**AMENDMENT #1 IFB004DPWT16 (C)** Qualified Contractors to furnish all labor, tools, equipment, machinery and supply for the Moravian Highway Pavement Rehabilitation Route 30-Project No. VI-0030 (039) on St. Thomas, Virgin Islands.

**ADDENDUM #1 – IFB-004-DPW-T-2016(C)**

**Project No. VI-30(39) Moravian Highway Pavement Rehabilitation - St Thomas**

### **TYPICAL WALL DETAIL**

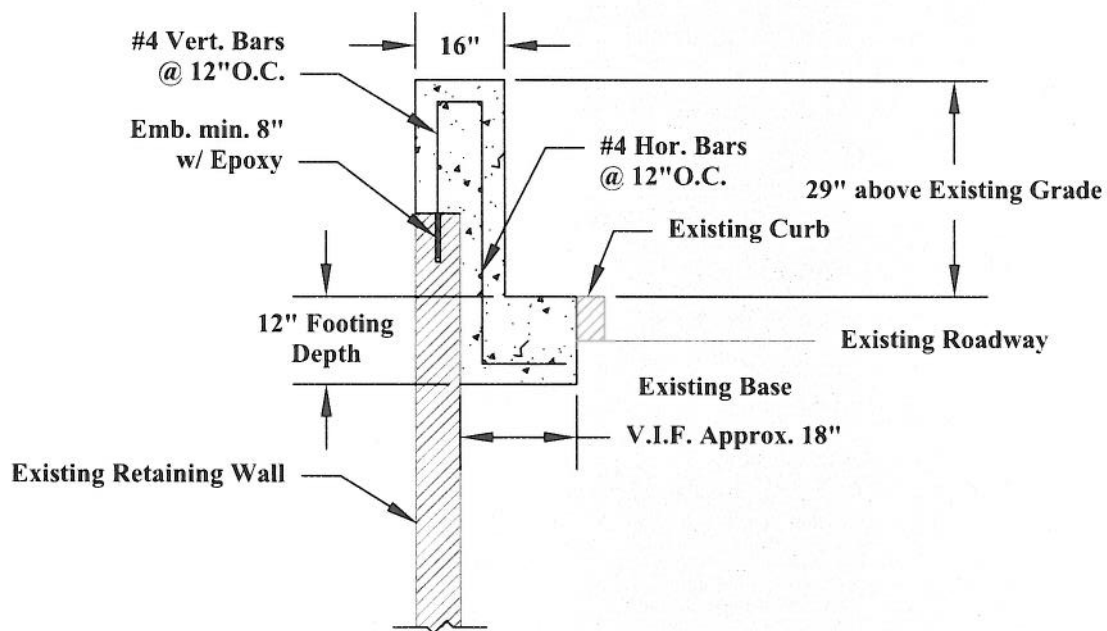
2. Sheet 9 – Wall Detail replaced with sketch SK-1

This Sketch Modifies Sheet 9
